Access Compliance Report

Public Rights-of-Way (Curb Ramps)

Intersection ID: 15217	Main Street: ALBEMARLE_RD	Cross Street: WINTERHAVEN_DR	Location: SW
ADA ID: 359BF5111939	Ramp Type: Perp	Initial Pass/Fail: Fail	Overall Compliance: No
Severity Score: 8.75			
Codes/Mitigation Info/Possible Solution		Field Measurements/Component Compliance

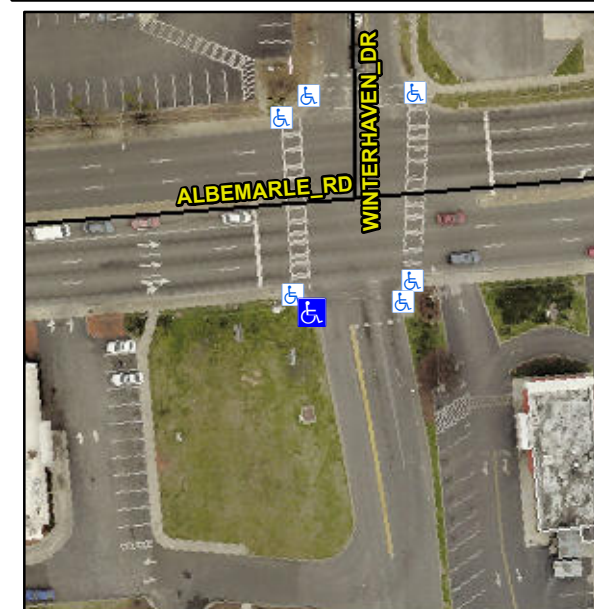
Compliance	Description	Data	Compliance	Description	Data
N/A	Ramp Length (in)	61.0	Yes	Ramp Slope (%)	7.5
No	Ramp Width (in)	41.0	Yes	Ramp XSlope (%)	1.1
N/A	Flare Type LT	N/A	N/A	Flare Type RT	N/A
N/A	Flare Slope LT (%)	N/A	N/A	Flare Slope RT (%)	N/A
N/A	Flare Traversable LT?	N/A	N/A	Flare Traversable RT?	N/A
N/A	Landing Length (in)	N/A	N/A	DWS Provided?	N/A
N/A	Landing Width (in)	N/A	N/A	DWS Contrast?	N/A
N/A	Landing Slope (%)	N/A	N/A	DWS Length (in)	N/A
N/A	Landing X Slope (%)	N/A	N/A	DWS Full Width?	N/A
N/A	Landing Curb? (Y/N)	N/A	N/A	DWS Offset (in)	N/A
N/A	Shared Landing?	N/A			
N/A	Gutter Ponding?	N/A	N/A	Gutter Slope (%)	N/A
N/A	Gutter Lip Ht (in)	N/A	N/A	Gutter X Slope (%)	N/A
N/A	Painted X Walk1?	Yes	N/A	Painted X Walk2?	N/A
	X Walk 1 Direction	To E		X Walk 2 Direction	N/A
N/A	X Walk 1 Width (in)	89.5	N/A	X Walk 2 Width (in)	N/A
	X Walk 1 Slope (%)	3.2		X Walk 2 Slope (%)	N/A
	X Walk 1 X Slope (%)	0.7		X Walk 2 X Slope (%)	N/A

N/A	Ramp inside XWalk1?	No	N/A	Ramp inside XWalk2?	N/A
	Road Slope (%)	N/A	N/A	Clear Space?	N/A
	Road X Slope (%)	N/A	N/A	Clear Space to XWalk (in)	N/A
N/A	Any Obstructions?	N/A	N/A	Storm Grate/Utility Hazard?	N/A
	Obstruction Type			Storm Grate/Utility Type	
		N/A			N/A
		Yes		Surface Condition? (G/P)	Good

**Remove & Replace Entire Ramp.
Restripe Crosswalk.**
